01 - 2010
BDF453 / BDF453Z / BDF453H
18V 1/2" DRIVER DRILL

SERVICE CHANGES

1. Changes on Switch, Terminal, and Housing Set (Battery Protection Circuit)

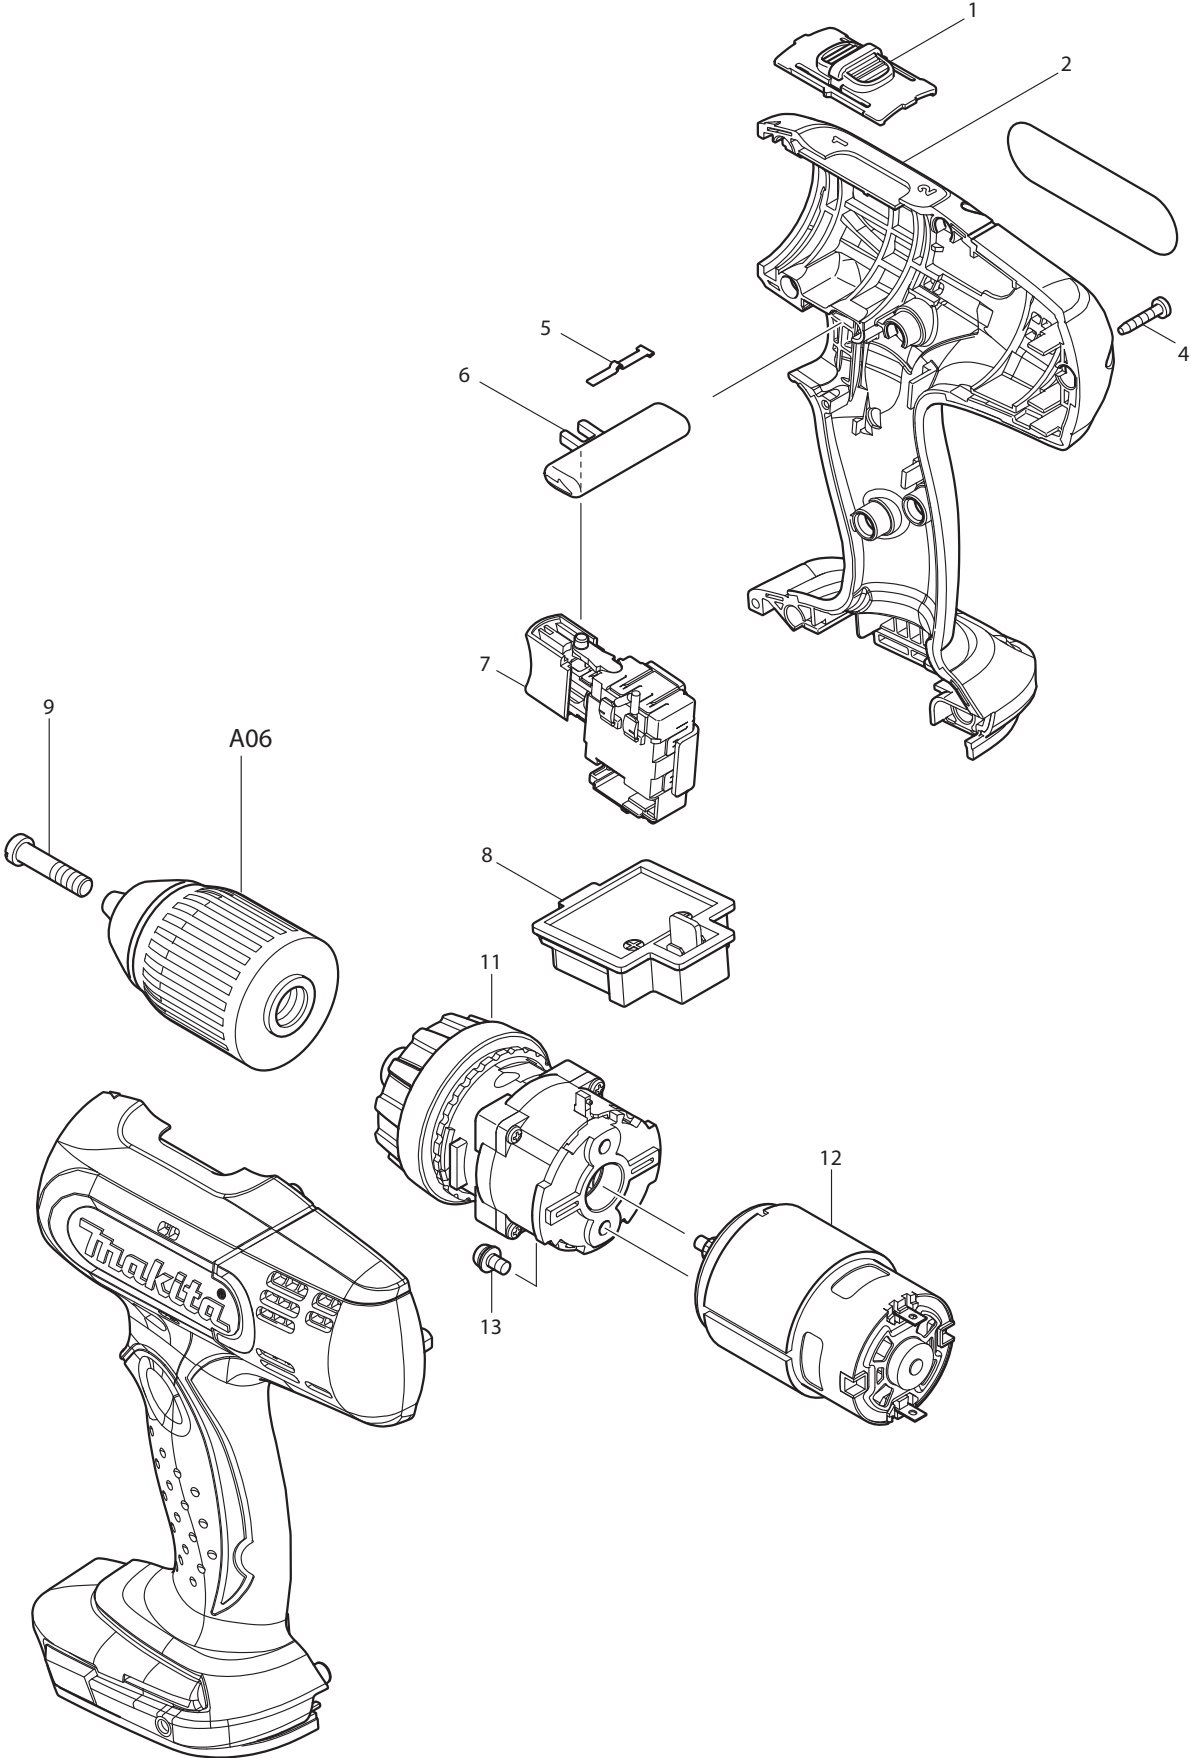
Item No.	Description	Type 1	Type 2	Type 3
2	HOUSING SET		188542-5	187363-2
7	SWITCH		650604-4	632A24-0
8	TERMINAL	643812-4	643844-1	643852-2

Above parts are completely interchangeable as a set.

- Use new parts for repair of the model manufactured on or after December 2011 with using Yellow lead wire between Switch and Terminal.
- Use current parts for repair of the model manufactured before December 2011 without using Yellow lead wire between Switch and Terminal.
